Re: Florida Power & Light Company
Proposed Turkey Point Units 6 and 7
Docket Nos. 52-040 and 52-041
Response to NRC Request for Additional Information Letter 120329
(eRAI 6354 Rev. 0) Related to ESRP Section 2.3.1 - Hydrology

L-2012-337
10 CFR 52.3

Re: Florida Power & Light Company
Proposed Turkey Point Units 6 and 7
Docket Nos. 52-040 and 52-041
Response to NRC Request for Additional Information Letter 120329
(eRAI 6354 Rev. 0) Related to ESRP Section 2.3.1 - Hydrology

Figure 1. Extent of "Continuous Seagrass" and "Patchy (Discontinuous) Seagrass"

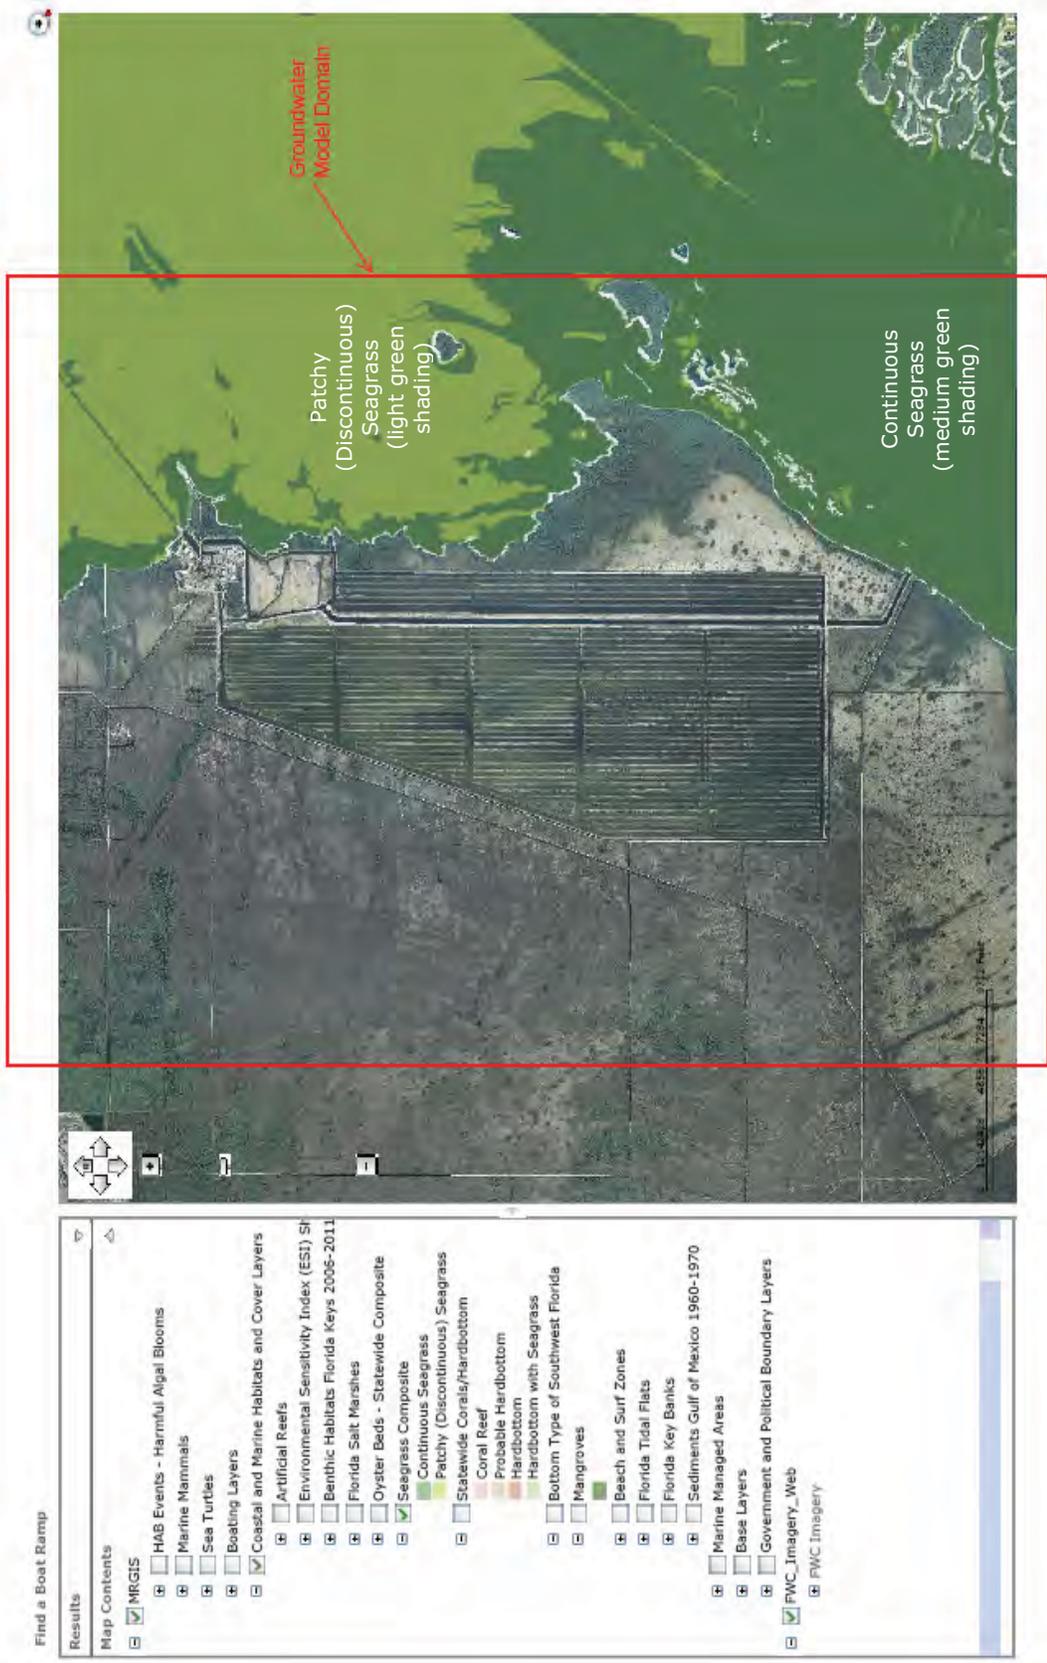
Provide any available information on how measurements of the hydraulic conductivity of the sediment found at the bottom of Biscayne Bay were determined.

The extent of the above benthic zones within the model domain is shown on two figures provided with this response:

- Figure 1 – Extent of "Continuous Seagrass" and "Patchy (Discontinuous) Seagrass" (FWRI 2012)
- Figure 2 – Extent of "Hardbottom with Seagrass" and "Mangroves" (FWRI 2012)

A seagrass survey was conducted in 2009 along 26 transects surrounding the Turkey Point peninsula (EAI 2009). The transects extended to approximately 300 m from the shoreline. The seagrass in this area includes turtle grass (*Thalassia testudinum*) and, to a lesser extent, shoal grass (*Halodule wrightii*). *Thalassia* seagrass coverage ranged from 0% (not present) to >90%, with highest coverage immediately surrounding the peninsula (Figure 2 in EAI 2009). The area with greater than 50% seagrass coverage is consistent with the extent of the MRGIS zone around Turkey Point of “Continuous Seagrass” shown in Figure 1 of this response.
